DETAILED ACTION

LUDECKE.et al.

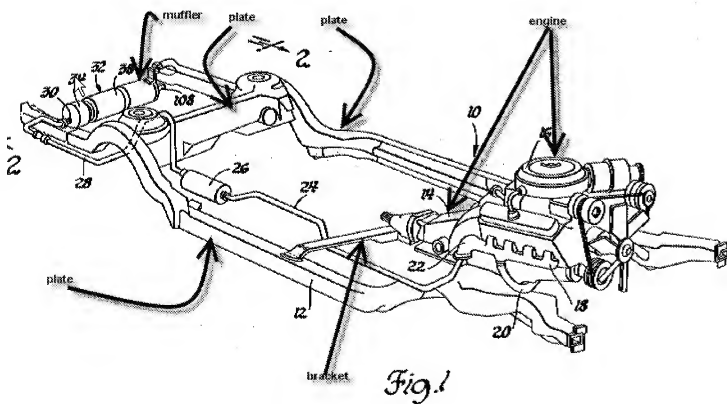
4. Claims 21-23 are rejected under 35 U.S.C. 102(b) as being anticipated by Ludecke et al. (US Patent 4,264,344).

Ludecke et al. teaches an exhaust system mounting assembly including: a bracket (see above) having a first and second bracket portion, the first bracket portion being adapted to be connected to an engine block (14) and a supporting element including a plurality of plates (clearly labeled above) arranged in stacked relationship (one on top of the other), the supporting element having a first end connected to the second bracket portion and a second end connected to an exhaust component (muffler). The plates have corresponding cross-sections as seen in a longitudinal direction.

Re claim 23, the assembly includes a console (as shown above) that connects the second end of the supporting element to the exhaust system component. The plates are band-like because they are assembled or united in a group, as defined by the American Heritage Dictionary of the English Language.
